CALIFORNIA COASTAL COMMISSION

STAFF REPORT: PERMIT AMENDMENT

APPLICATION NO.: 4-99-169-A1

PROJECT LOCATION: 25126 Pacific Coast Highway, City of Malibu (Los Angeles County)

EXHIBIT NO. 8
APPLICATION NO.
4-99-169-A1
ARTIFACT MAPS (4pp)

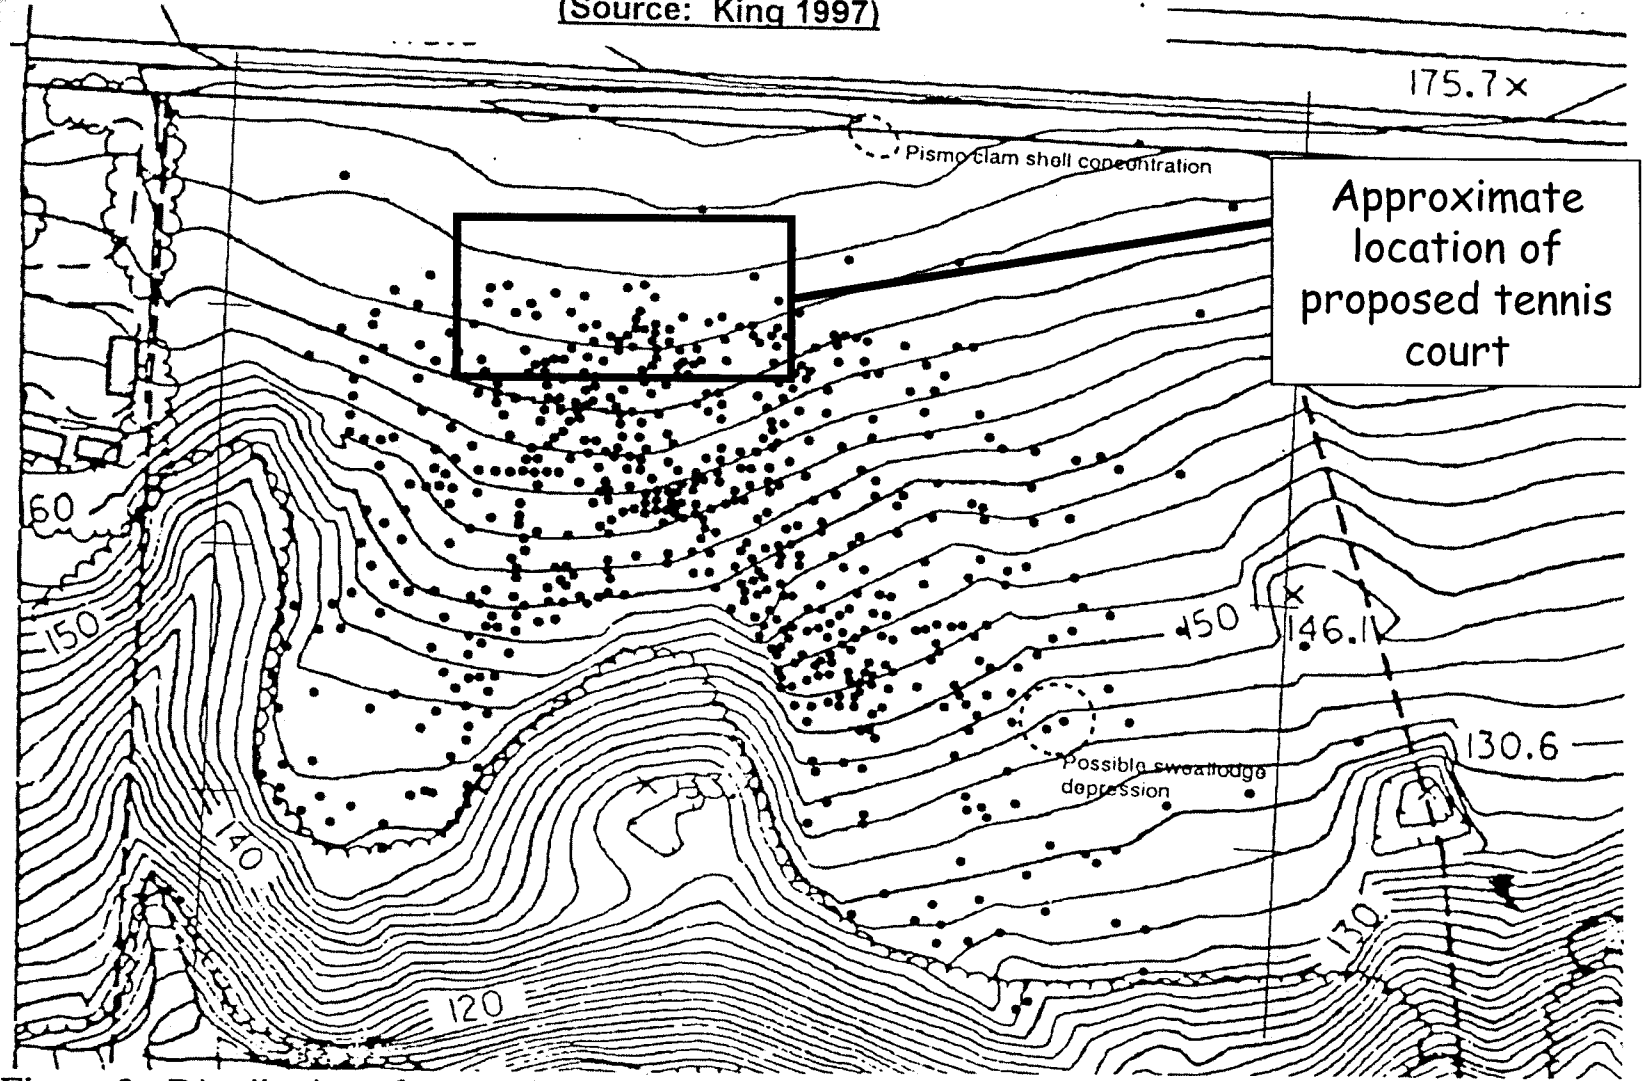
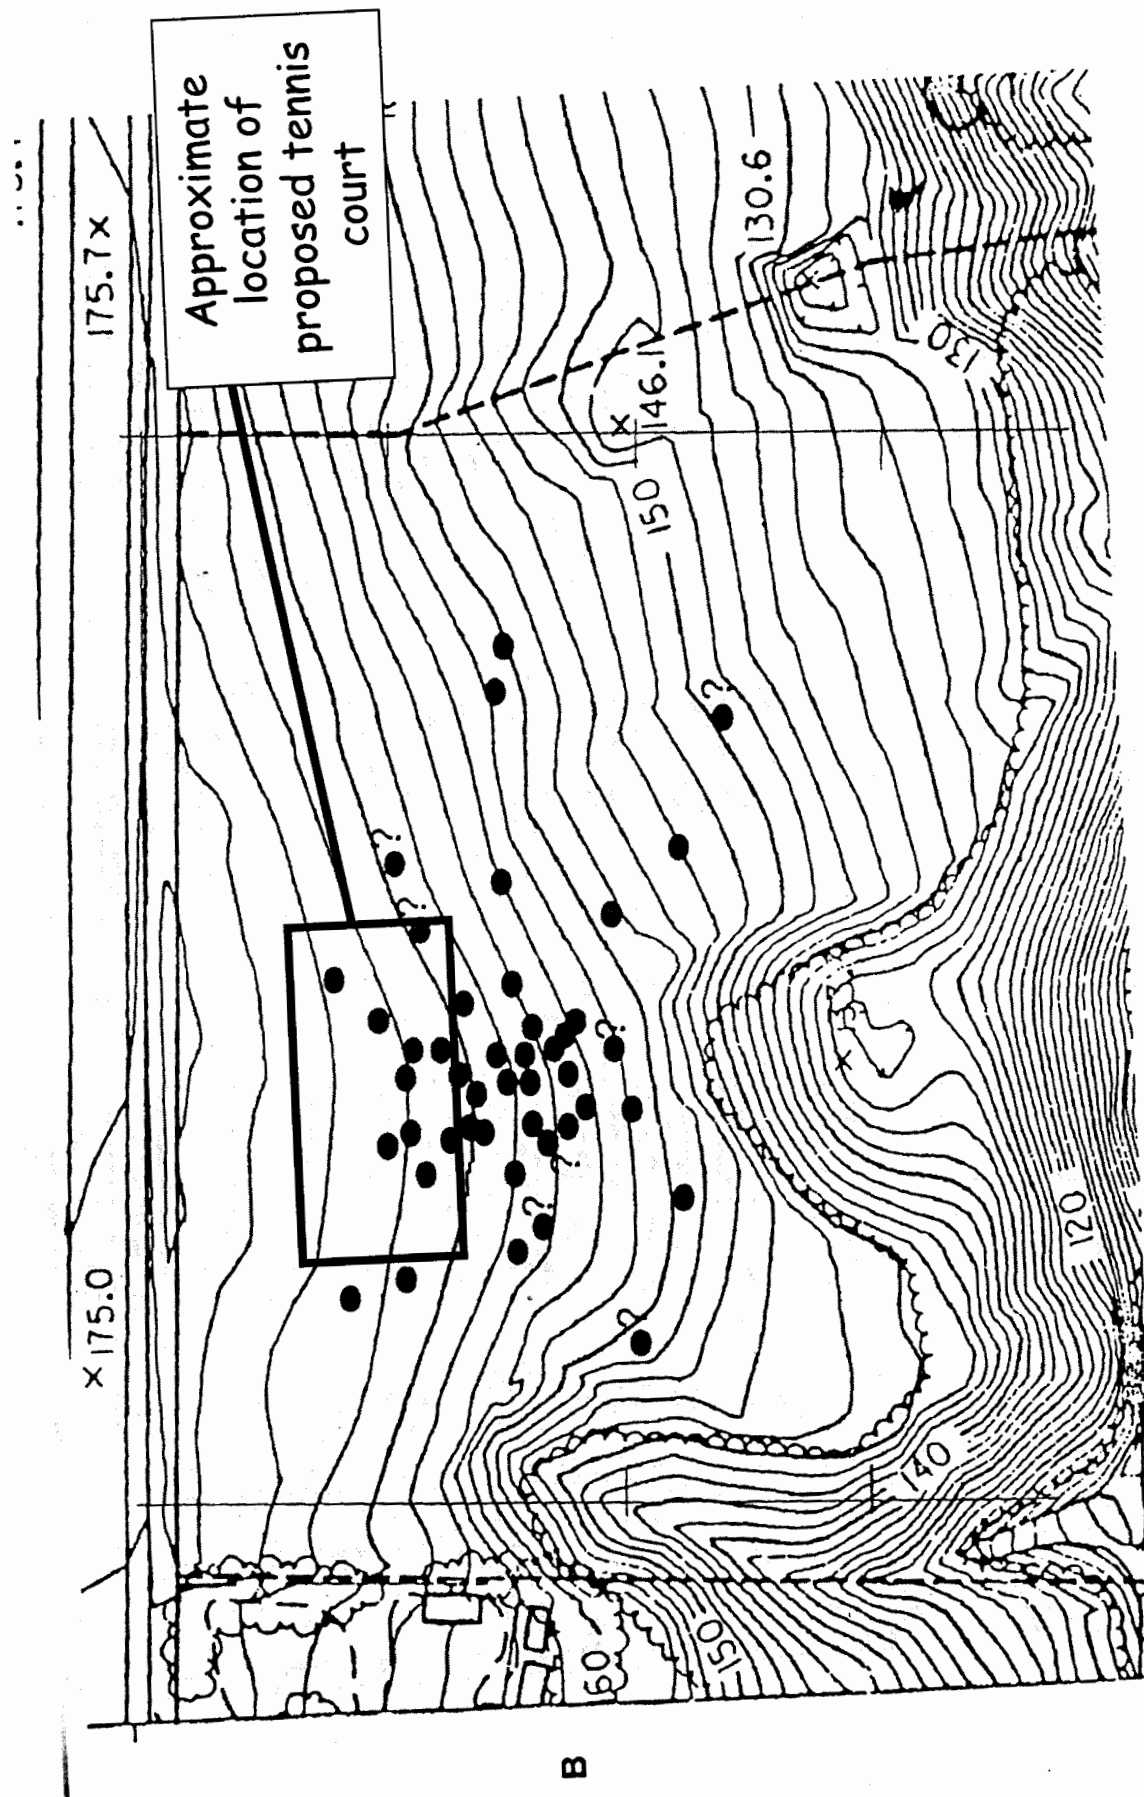
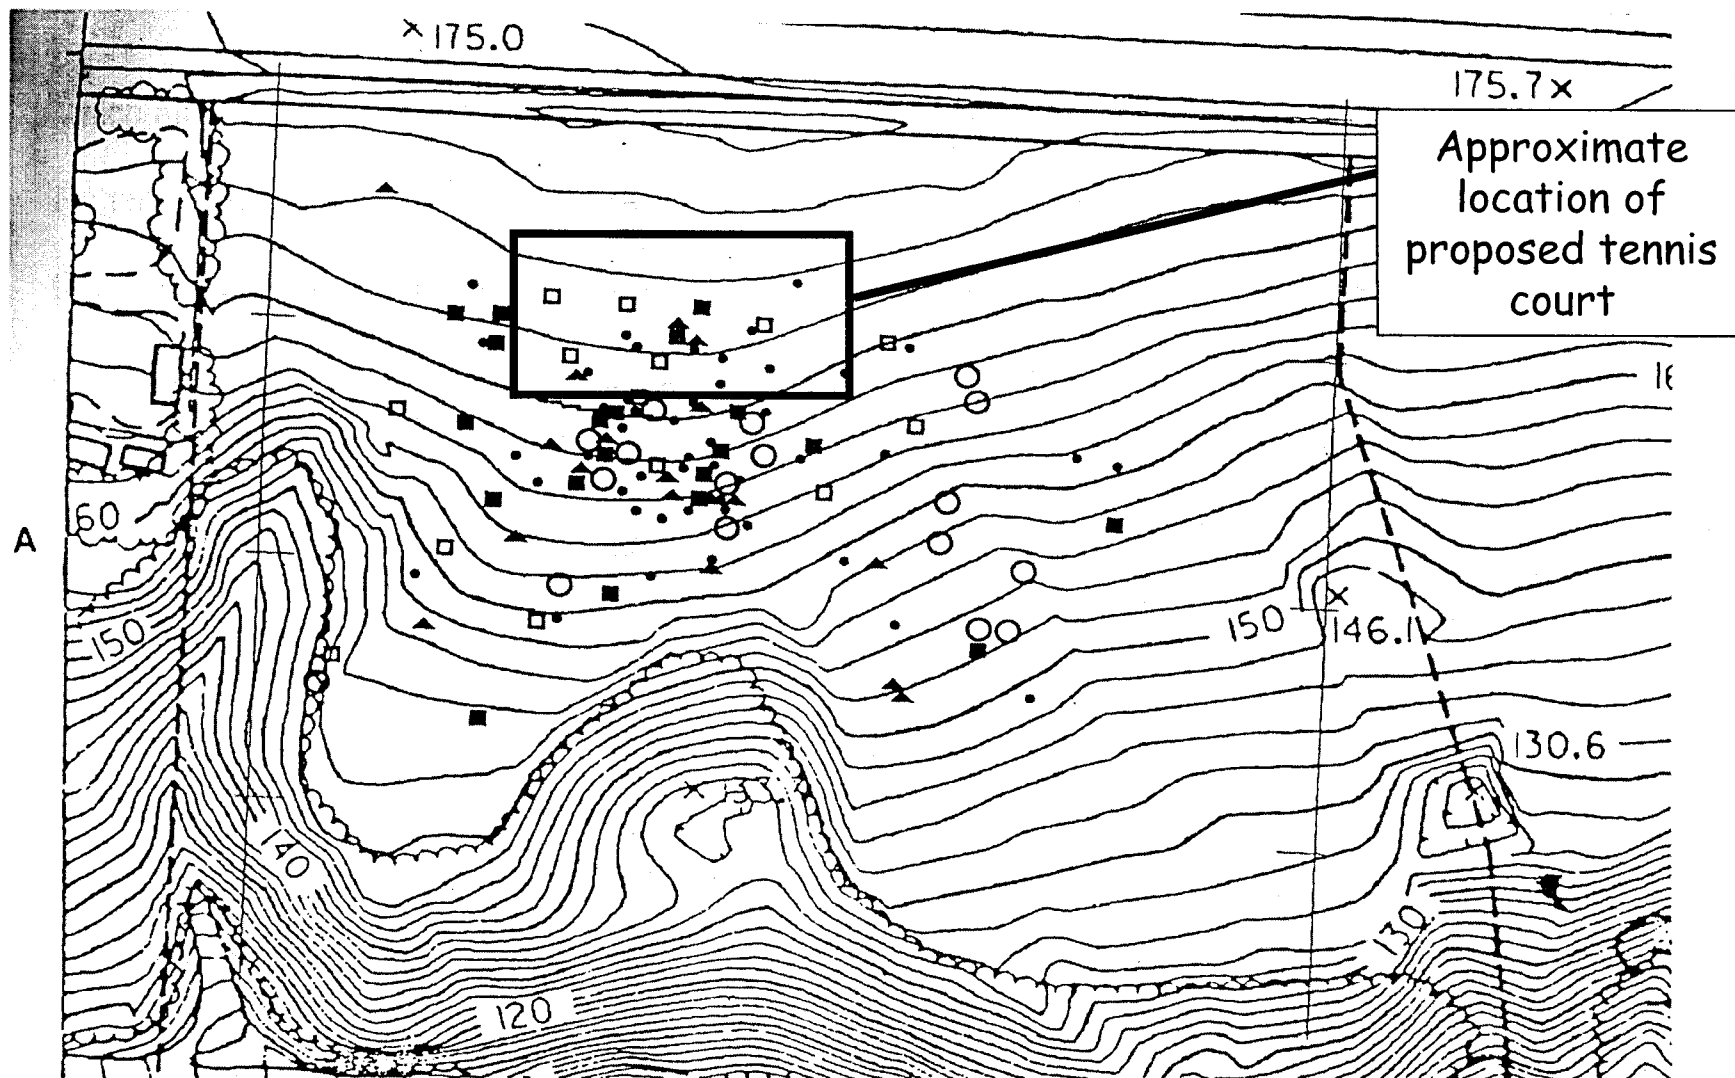
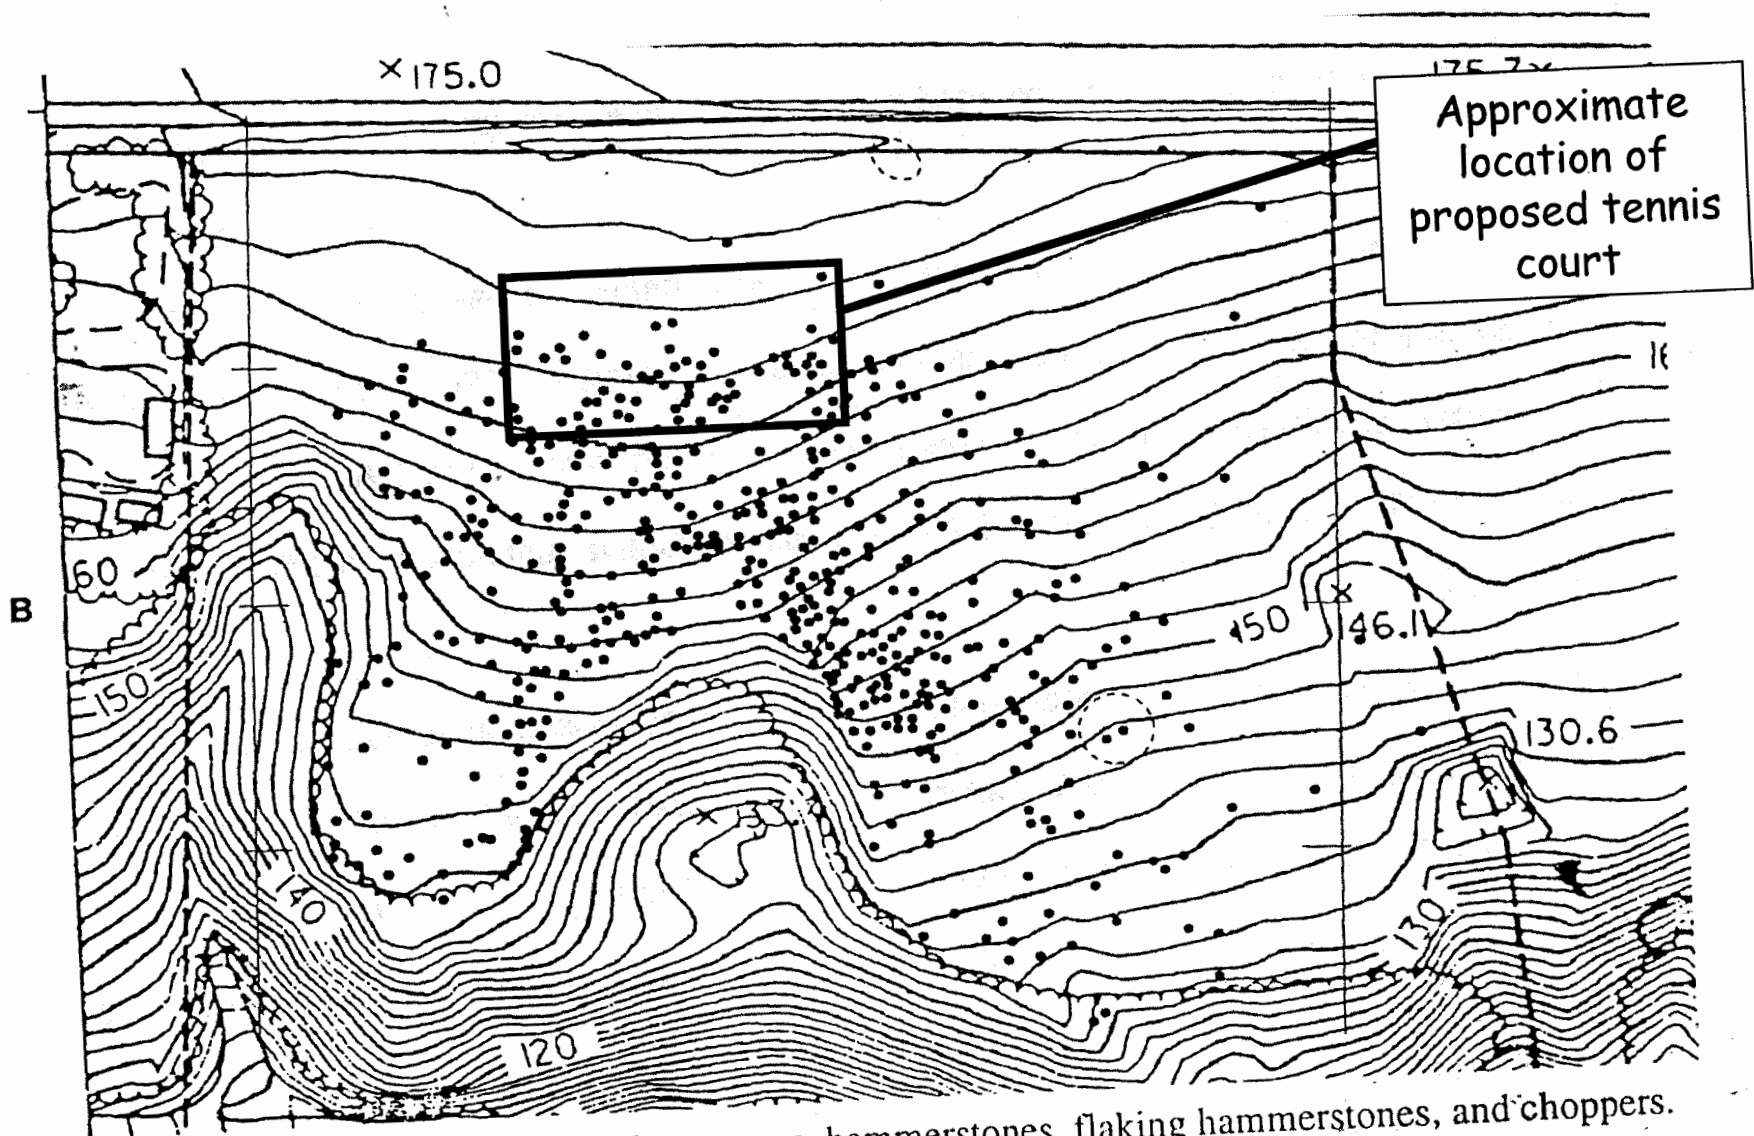
Several archaeological studies have been conducted on the project site. A mapping project conducted by Dr. Chester King and the National Park Service in 1998 located 626 artifacts on the surface, including manos, hammerstones, choppers, and a concentration of Pismo Clam shells. Several manos, hammerstones, choppers, and other artifacts were found within the footprint of the proposed tennis court.

EXHIBIT NO. 9
 APPLICATION NO.
 4-99-169-A1
 PHASE II STUDY MAP

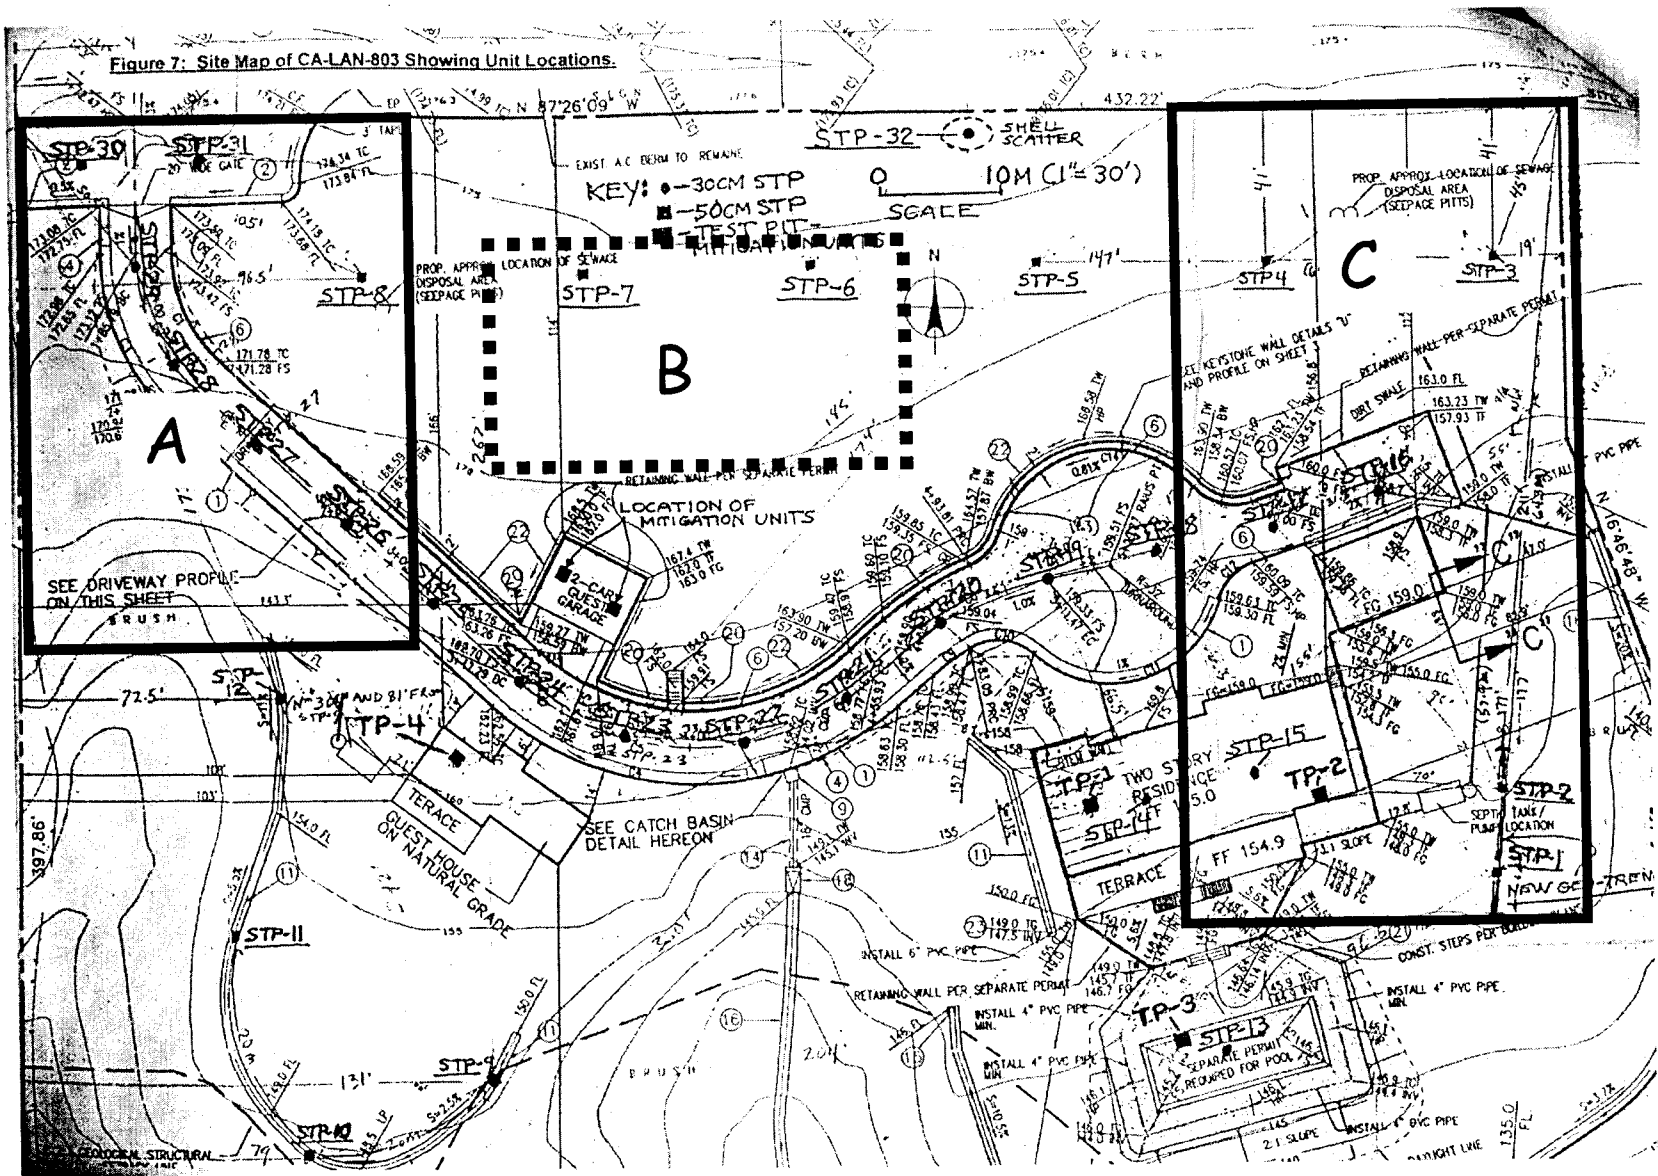
Although Dr. Stickel states that the tennis court area is the least sensitive of any area on the parcel, the Phase II study he conducted found a high volume of artifacts in two Shovel Test Pits (STPs) excavated within the footprint of the proposed tennis court, in comparison to other STPs excavated on site. The study found 18 artifacts in STP 7, more than in any of

the other 30 test pits excavated on site, and nine artifacts in STP 6, more than in 25 of the other 30 test pits excavated. Although the STPs within the proposed tennis court footprint contained no tools, tools were found in only five of the 31 STPs excavated. Other areas on the site contained far fewer artifacts. An approximately 25,000 sq. ft. area in the northeast portion of the parcel yielded only 18 artifacts and no tools from 7 STPs and one 1' x 1' test pit. An approximately 15,000 sq. ft. area in the northwest corner of the site yielded only nine artifacts and no tools from seven STPs.
